MAX CRUISE MOD BLOCK DEFINITION

PROGRESS REPORT

Date: 12 March 1976

Issue 2 21st April 1976

A-FIG 1-1-1(a) MAX. CRUISE ANALOGUE COMPUTING

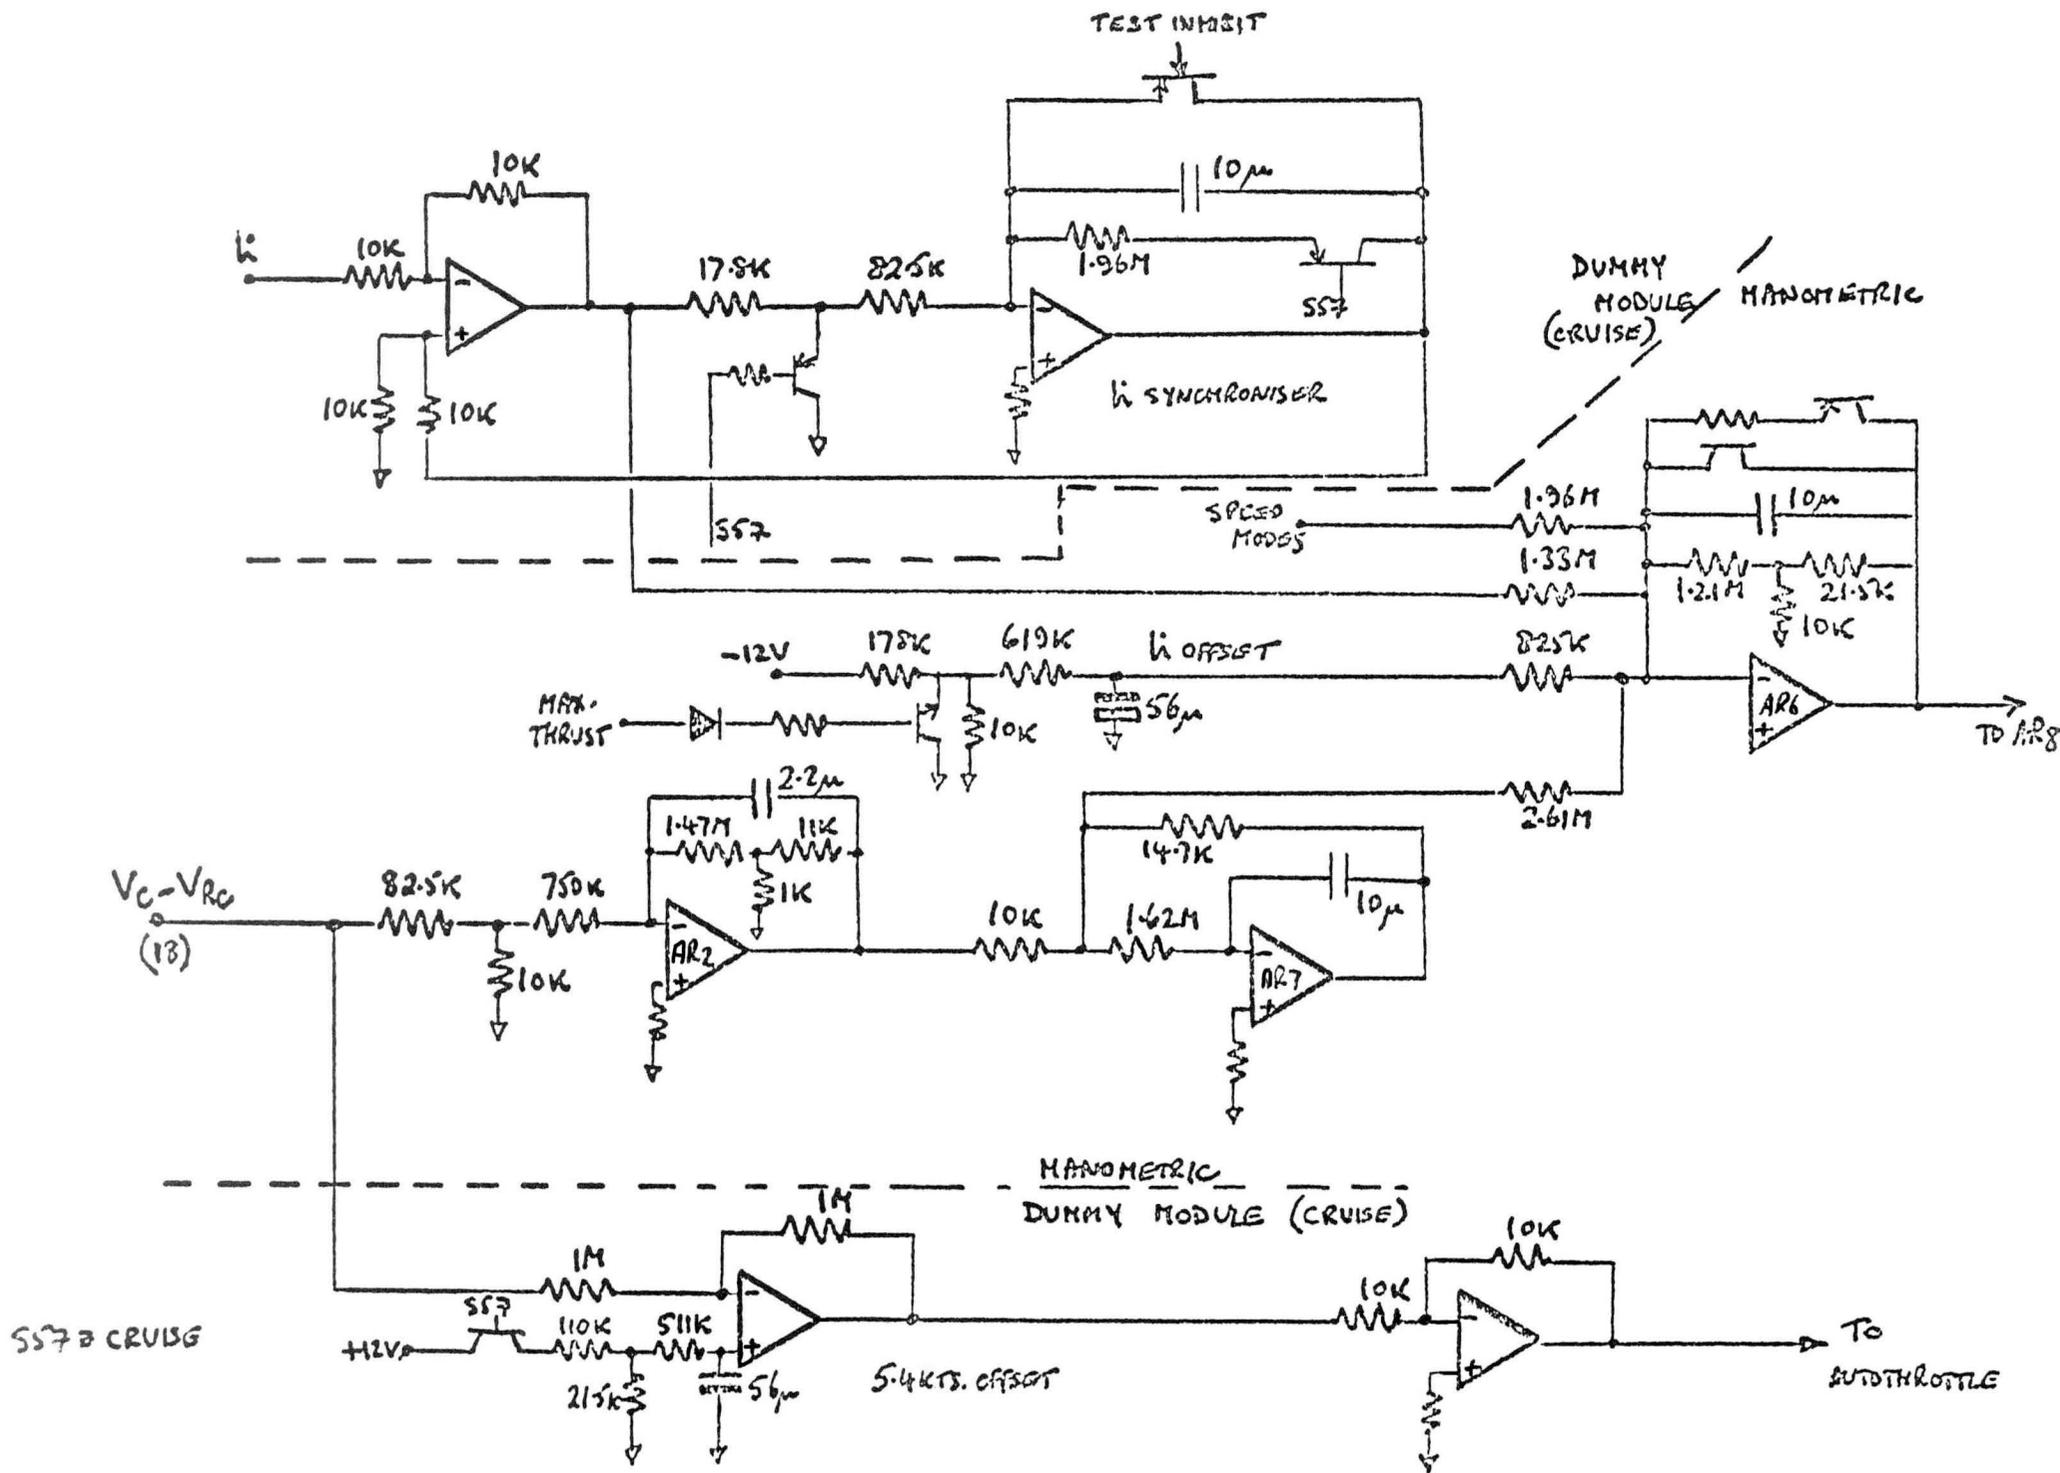
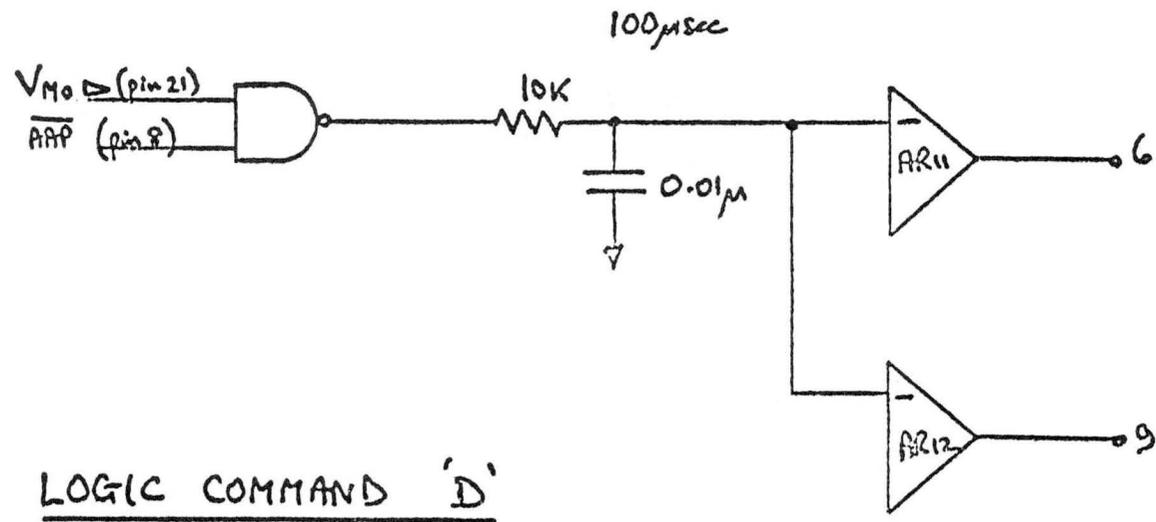
Fig 1-1-1 illustrates the analogue computing. The analogue signal from the ADC ( $V_c - VRC$ ) is used in a similar manner as at present to control the aircraft in Max Climb. For Max Cruise a second-order filter term is included in the  $V_c - VRC$  chain. To this is added an  $\dot{h}$  component which has been synchronised to zero before Max Cruise is engaged. An  $\dot{h}$  offset of 600'/min is also added (provided that none of the throttle levers is at maximum) to facilitate the speed control at the 50,000' VMO/MMO corner. A  $V_c - VRC$  level switch set to 5.4 kts (with 2.7 kts hysteresis) is used to clutch the Autothrottle in overspeed conditions. The analogue output to the Autothrottle is offset by 5.4 kts to ensure control is maintained at M0.02

above the ADC datum of M 2.00. The FTCM rate limit is increased to 0.1 g/sec in all modes. Datum adjust authority remains as at present.

A - FIG. 1-1-2 AAP + Vmo OUTPUT

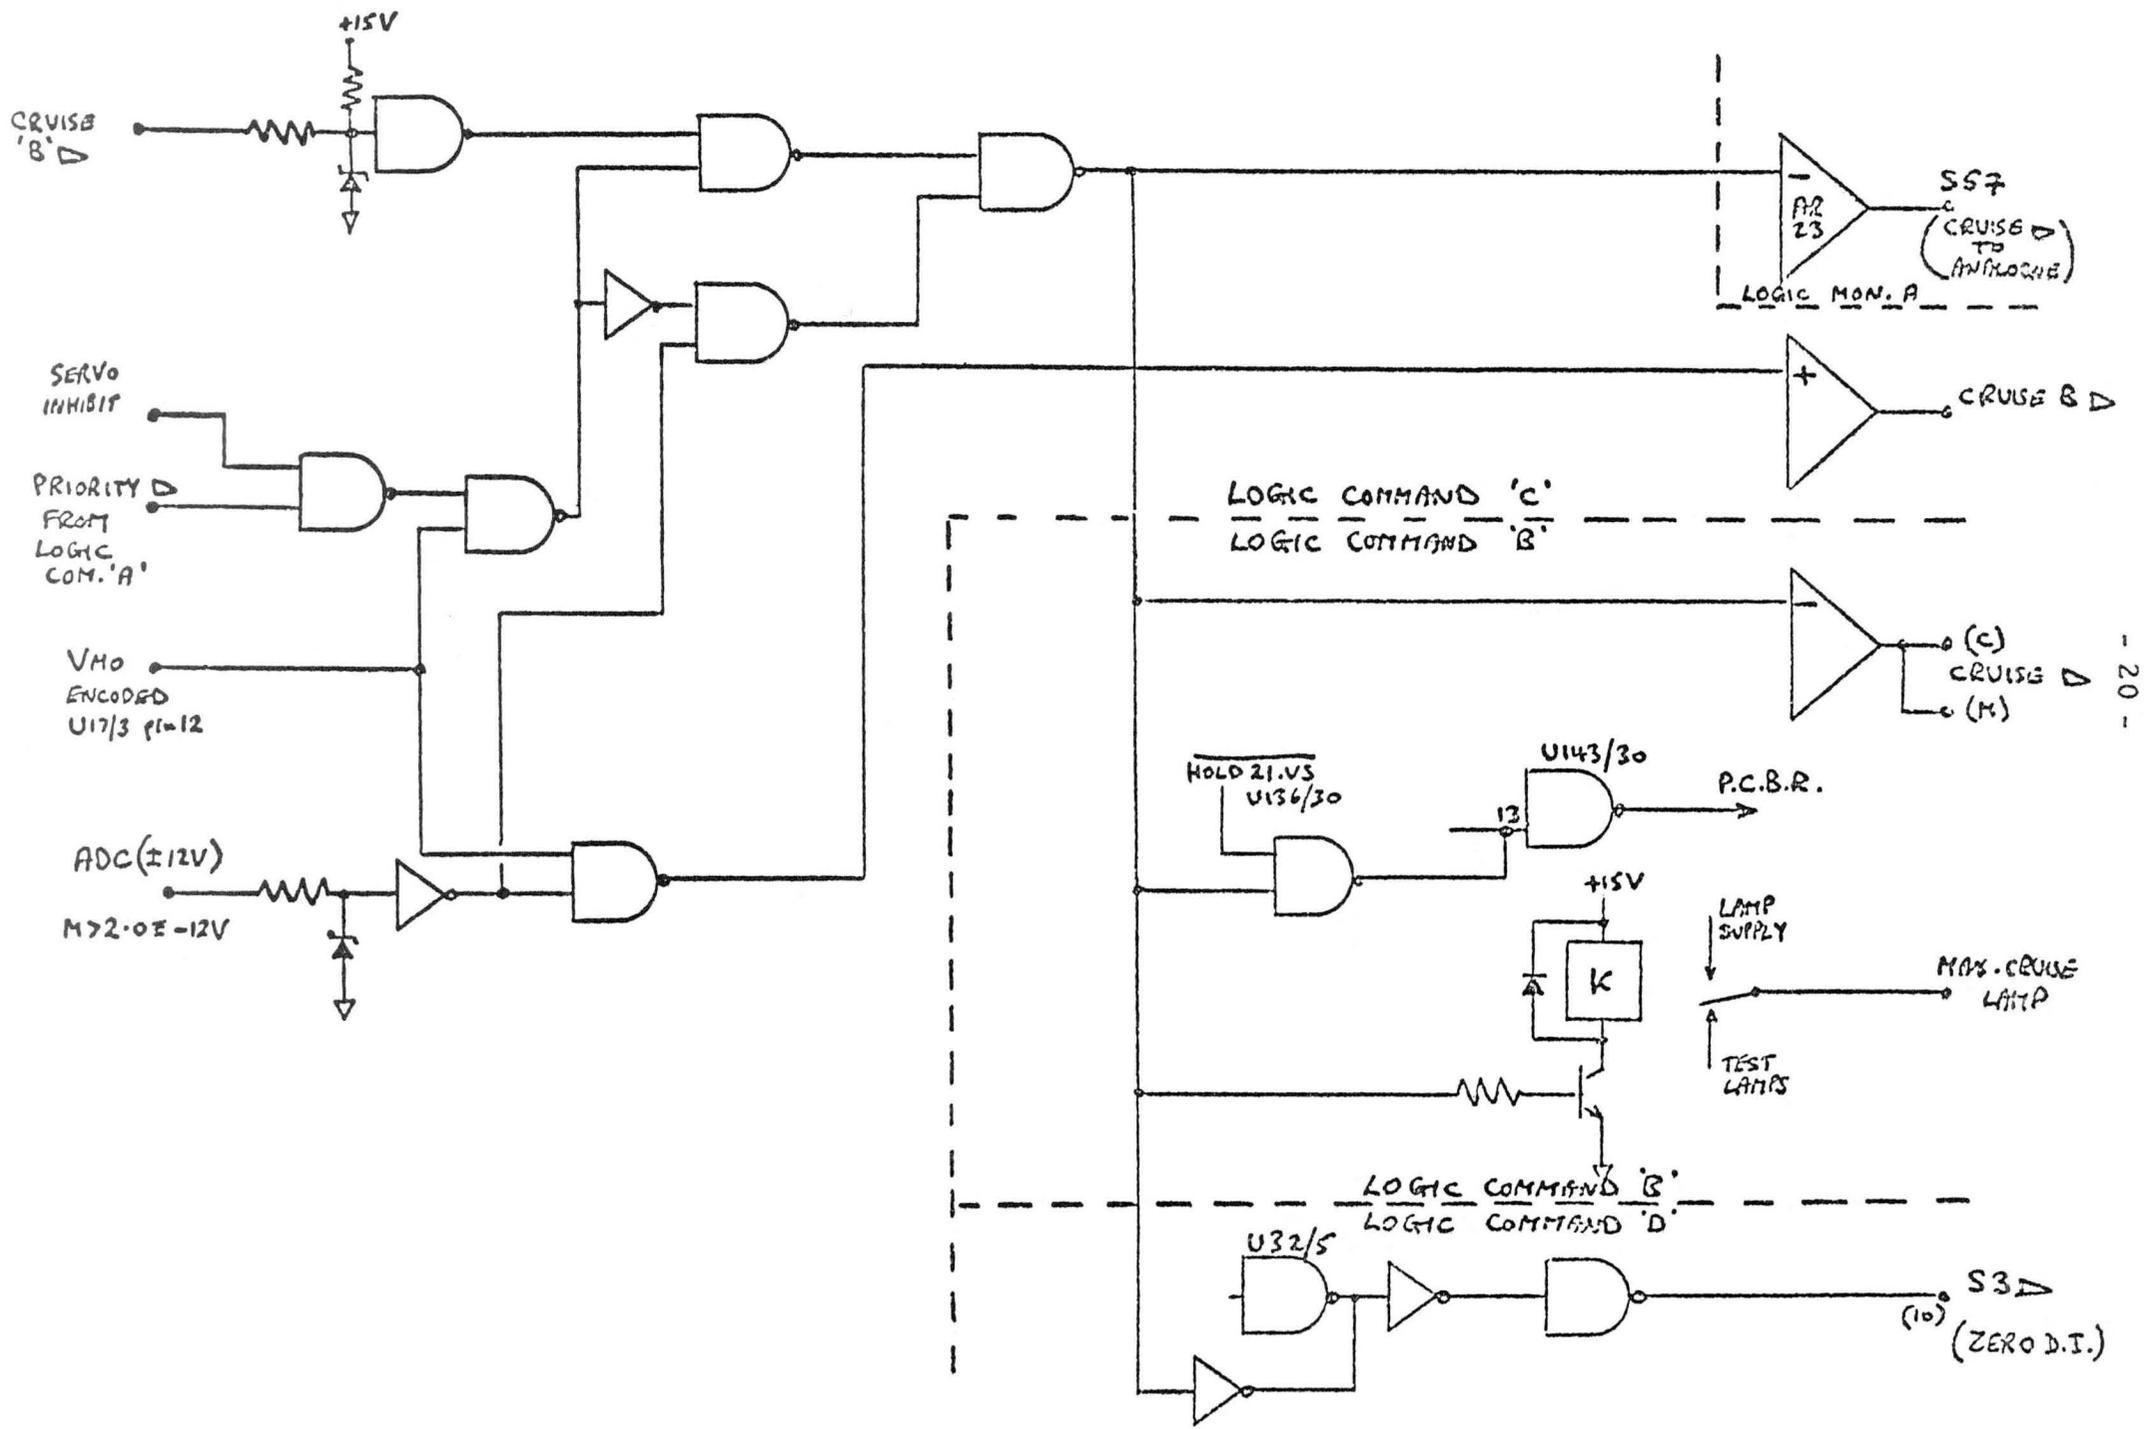
Fig. 1.1.2 shows the modified AAP logic output to the Autothrottle. A time delay of  $100\mu\text{sec}$  has been added to ensure that at the end of CRUISE when, say, Pitch is selected that AP Speed Mode disappears before AAP + VMO. If it did not do so then the Autothrottle would disconnect due to AP Speed Mode being present without AAP + VMO.

A-FIG 1-1-3 CRUISE LOGIC

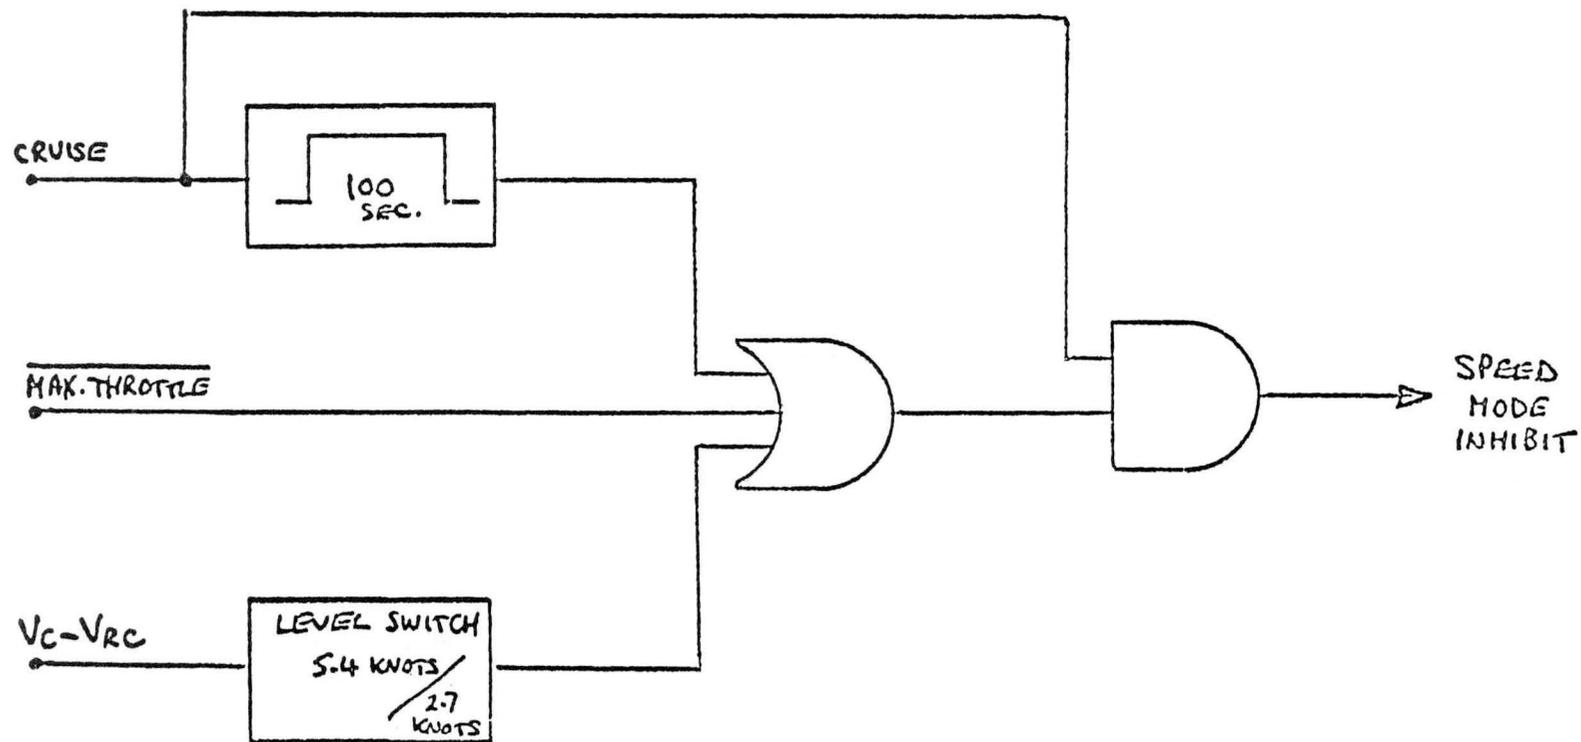
Fig. 1.1.3 illustrates the CRUISE logic. The signal CRUISE is generated under the following logical conditions -

ADC interlock, VMO encoded, (Priority + Servo Inhibit)  
or Cruise B from other AP.  $\overline{\text{Priority}}$ ,  $\overline{\text{Servo inhibit}}$

Cruise B is generated from

ADC interlock and VMO mode encoded, and is used in the opposite APFD computer to ensure mode switching and lamp illumination compatibility. It is also used, together with 'priority' to remove the Pitch Command Bars if this APFD is not in control.

The logic ensures compatibility with the Autothrottle under two conditions -

With one autopilot engaged in CRUISE engagement of the opposite Autopilot should result in the selection of PITCH hold mode and both autothrottles remain in standby. Under the original scheme the priority signal was temporarily absent during the changeover and as a consequence the generation of the signal CRUISE was lost in the system being engaged. This resulted in the associated Autothrottle system reverting to IAS Hold with the other autothrottle remaining in standby (Mach Hold). The present logic utilises the servo inhibit signal to replace the absent priority signal, thus ensuring that both autothrottles encode the same mode.

With FD1 (or FD2) engaged in CRUISE selection of AP2 (or AP1) should revert the system to Pitch Hold. However, because of the inherent time delays involved in performing this changeover it was possible for the autothrottle systems to encode different modes in each channel. The present logic ensures that conditions are identical in both APFD channels (via the CRUISE B signal) long enough for both autothrottle systems to end up in the same mode (Mach Hold).

A - FIG. 1-1-4 (a) MAX. CRUISE - SPEED MODE INHIBIT

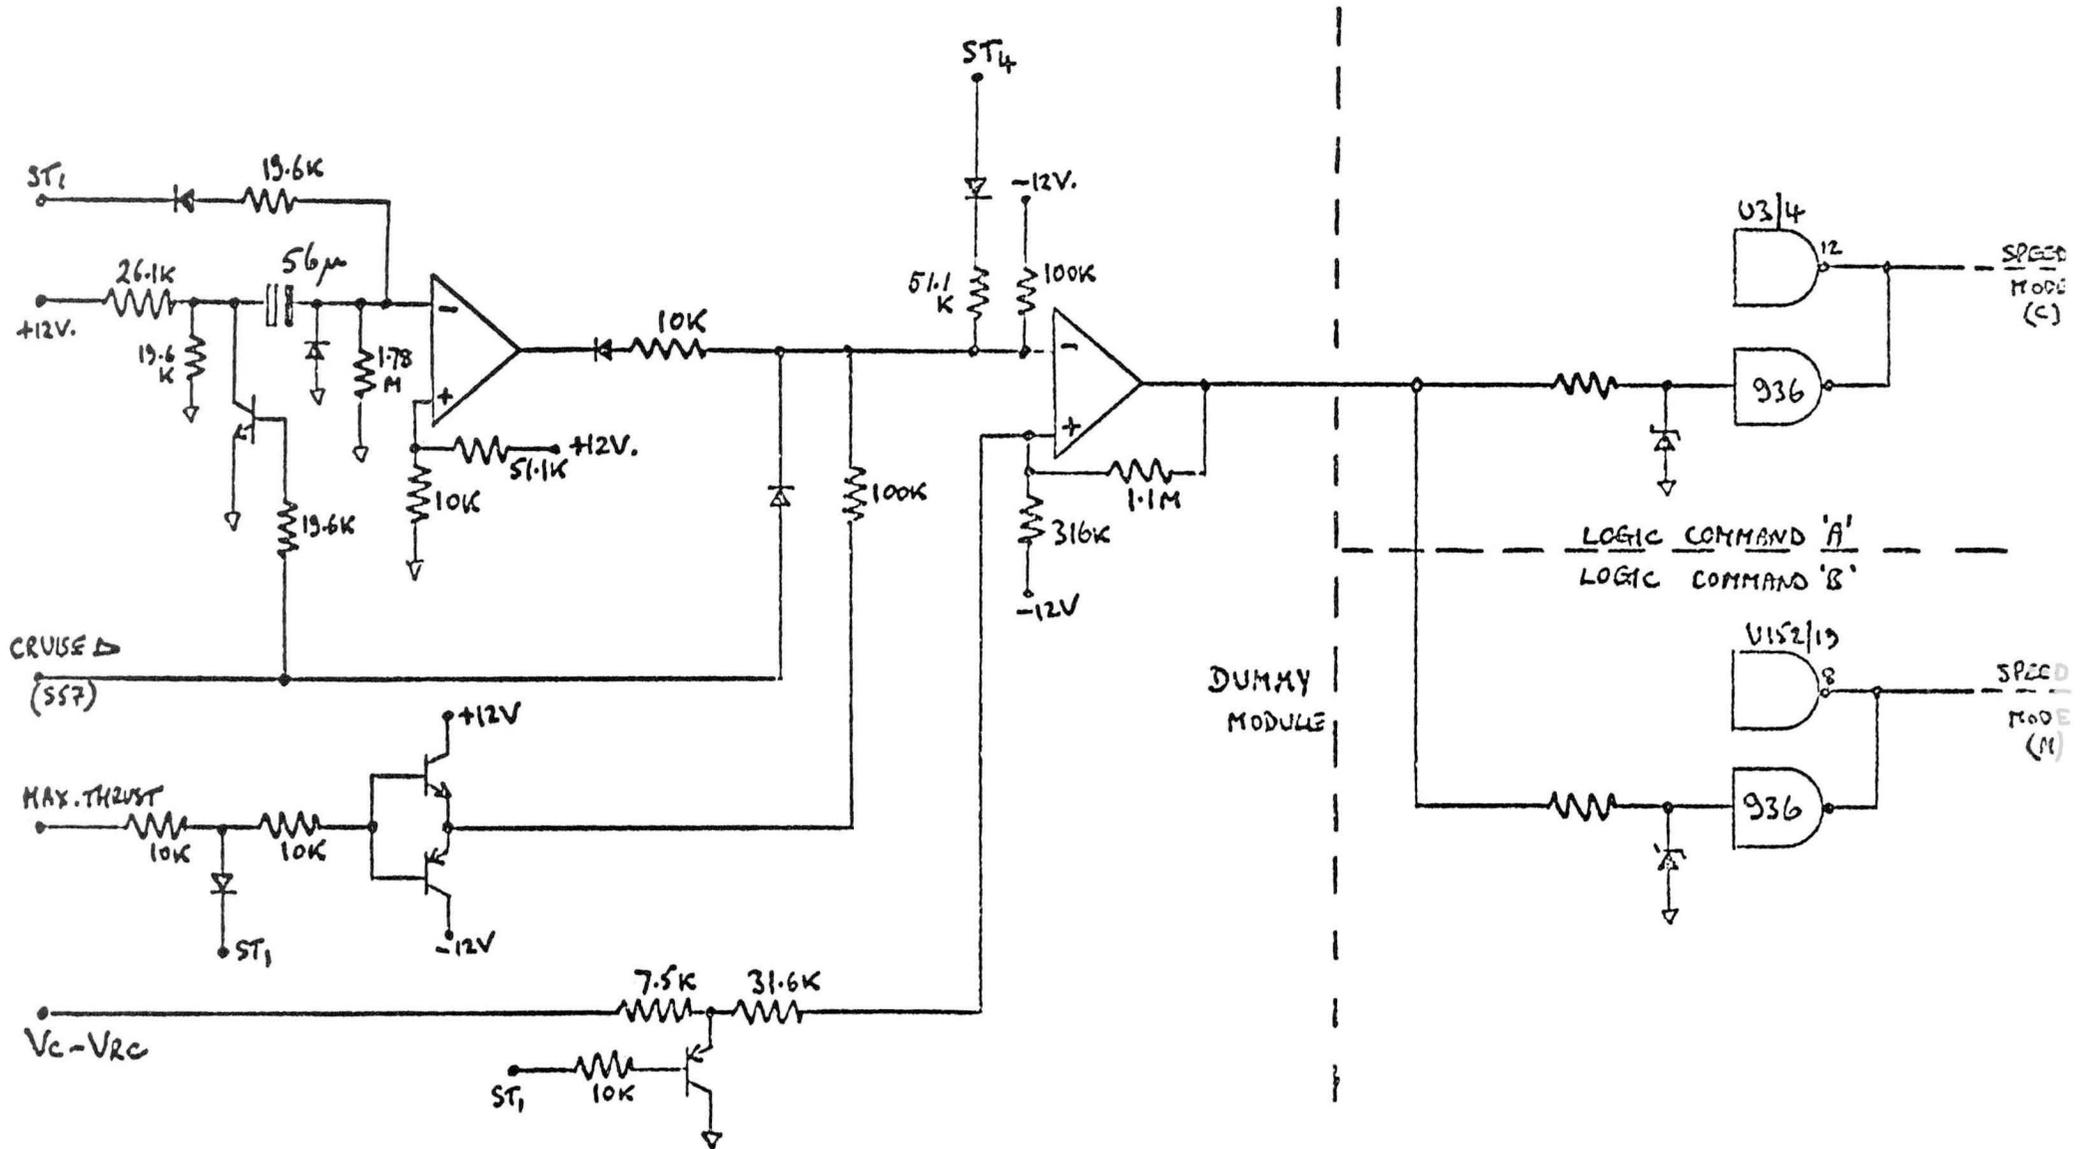
Fig. 1.1.4 shows the Speed Mode inhibit logic. This logic inhibits the AP Speed Mode output under the following conditions -

- CRUISE signal generated (for 100 secs)
- $V_c - VRC > 5.4$  kts

The inhibit is removed when one of the throttle levers has reached its maximum position and  $V_c - VRC < 2.7$  kts.
